Access Compliance Report Public Rights-of-Way (Curb Ramps)

Main Street: N/A Cross Street: FLINTRIDGE_AVE Location: NW

ADA ID: RPAT220125094853 Ramp Type: Type 4 - Parallel Initial Pass/Fail: Fail Overall Compliance: No Severity Score: 15

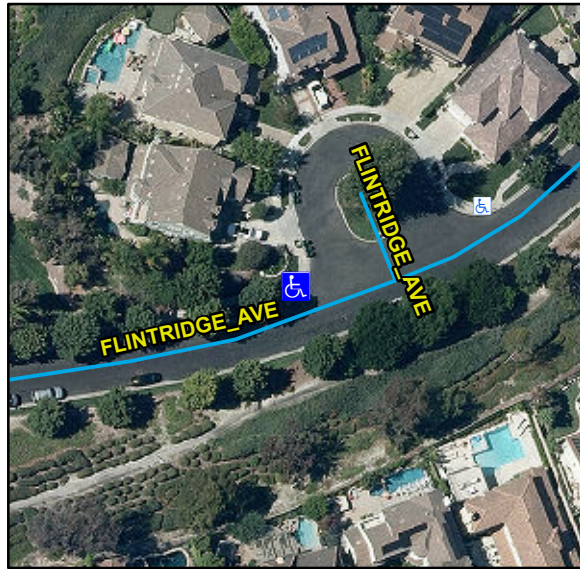
R204.3, R304.3.2, STD 1115

Compliance	Description	Data	Compliance	Description	Data
N/A	Ramp Length LT (in)	80	N/A	Ramp Length RT (in)	76
Yes	Ramp Width LT (in)	54	Yes	Ramp Width RT (in)	54
Yes	Ramp Run Slope LT (%)	0.2	No	Ramp Run Slope RT (%)	10
Yes	Ramp Cross Slope LT (%)	0.3	Yes	Ramp Cross Slope RT (%)	1.2
N/A	Landing Present	N/A	N/A	DWS Provided	N/A
N/A	Landing Length (in)	N/A	N/A	DWS Contrast	N/A
N/A	Landing Width (in)	N/A	N/A	DWS Length (in)	N/A
N/A	Landing Run Slope (%)	N/A	N/A	DWS Full Width	N/A
N/A	Landing Cross Slope (%)	N/A		DWS Offset Type	N/A
N/A	Landing Movement Obstructed?	N/A	N/A	DWS Offset Left (in)	N/A
	Landing Movement Type	N/A	N/A	DWS Offset Right (in)	N/A
N/A	Landing Shared	N/A			
N/A	Clear Space	N/A			
N/A	Clear Space To Crosswalk (in)	N/A			
N/A	Marked Crosswalk 1	No	N/A	Marked Crosswalk 2	N/A
	Crossing 1 Direction	E		Crossing 2 Direction	N/A
N/A	Marked Crosswalk 1 Width (in)	N/A		Marked Crosswalk 2 Width (in)	N/A

Remove & Replace Entire Ramp.
